FACILITY: San Onofre Nuclear Generating Station, Units 2 and 3

SUBJECT: SUMMARY OF MEETING TO DISCUSS THE DETAILED CONTROL ROOM
DESIGN REVIEW

MINUTES OF MEETING
BETWEEN NRC AND SCE
ON THE
DETAILED CONTROL ROOM DESIGN REVIEW (DCRDR)
FOR
SAN ONOFRE, UNITS 2 AND 3

Figure 2.1-1 ORGANIZATION CHART OF THE CONTROL ROOM DESIGN REVIEW WORKING GROUP

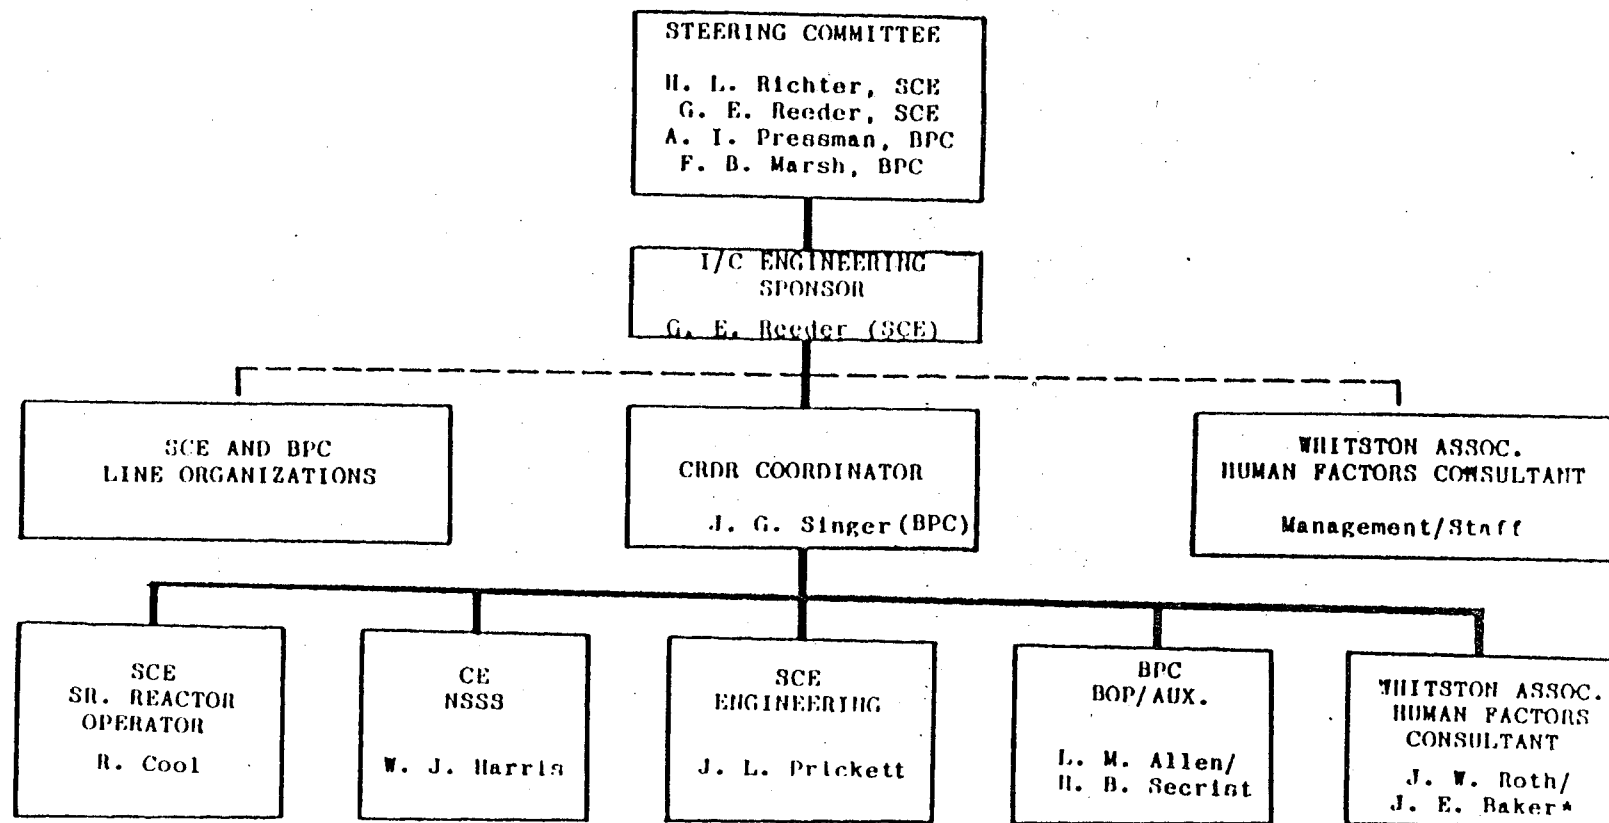
SCE elaborated on the expertise and task assignments of DCRDR team members and supplemental staff (see page 7 of Attachment 2). SCE provided information on organizations responsible for completion of DCRDR activities (see page 5 of Attachment 2). Although not reflected in the Summary Report, the licensee indicated that it relied heavily on SROs in the conduct of its efforts and utilized staff with extensive I&C expertise in a variety of fields including aerospace and the military. The licensee also addressed concerns raised in the evaluation of the Summary Report explaining that consultants from Whitston Associates provided human factors expertise. Whitston was also responsible for conducting an orientation program for review team staff which extended over a six month period of time. Throughout the entire effort, SCE management supported the effort and placed no constraints on the review team to complete its work.

As a result of the meeting, the NRC believes that SCE established a qualified multidisciplinary team to complete the work done in 1980 and 1981 to meet the requirements of a PDA for licensing. The information provided at the meeting should be documented and made available for audit. However, for work remaining to meet the requirements of Supplement 1 to NUREG-0737, the licensee should continue to have human factor professionals involved. The licensee should provide information or documentation to show that human factors expertise is being or will be utilized.

Figure 5.2-1 RECOMMENDED COMPONENT RELOCATIONS (TYPICAL)

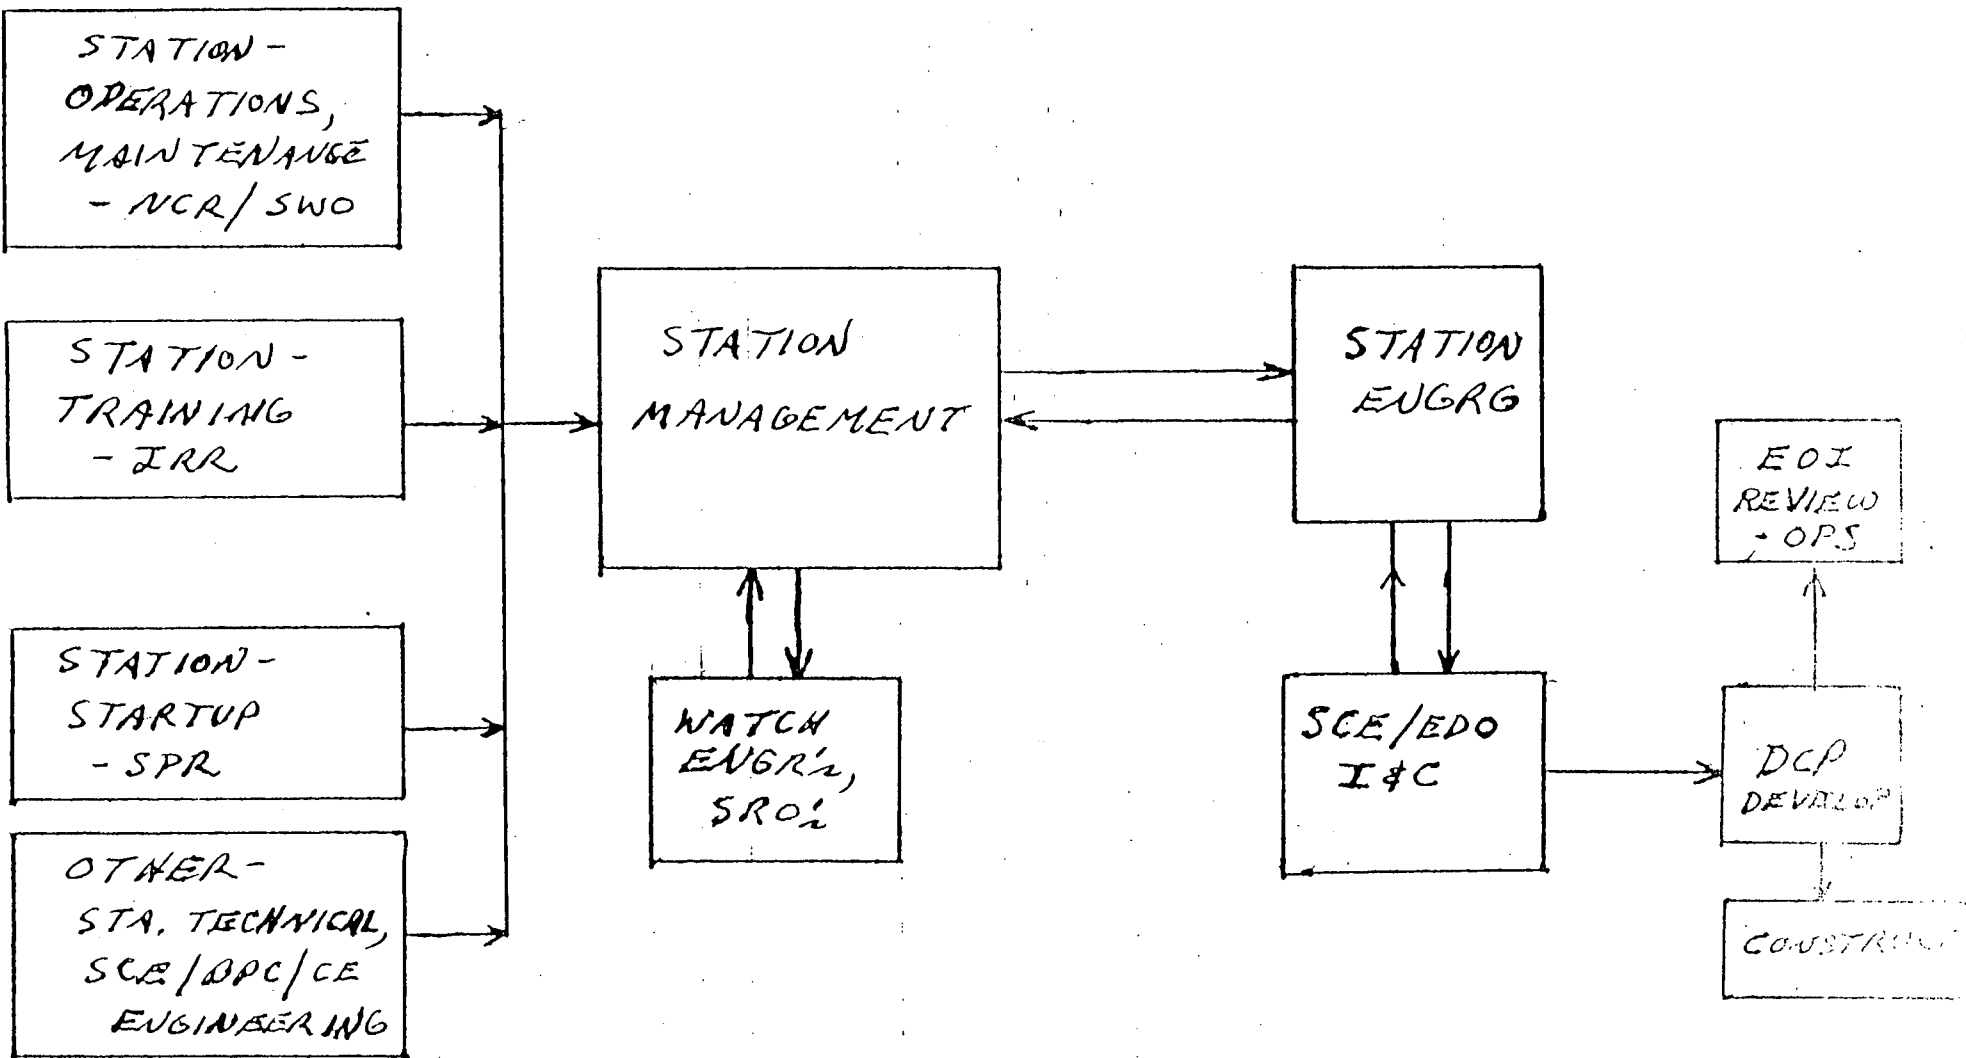
The HEDs which surfaced during the review included but were not limited to: identification of a few excess instruments, the identification of a few missing instruments, poor panel layout, and the need to adopt conventions such as labeling and color coding. How HEDs were assessed, individually and for aggregate effects, is unclear. The licensee should describe the formal HED assessment process in greater detail and provide relevant documentation. It should be noted that a more rigorous assessment process is envisioned by the NRC staff for a DCRDR, in contrast to HED assessment for a PDA.

The licensee described an evaluation process which was conducted to arrive at an ideal panel design that would correct panel layout HEDs. However, the licensee compromised its solution, and rather than implementing the ideal design which would have required extensive rework, the licensee decided that color coding, demarcation lines, mimics, training and operator familiarity would resolve most of these problems. Justification for these decisions and the process used to arrive at them should be provided (particularly for those HEDs with safety significance that were only partially corrected).
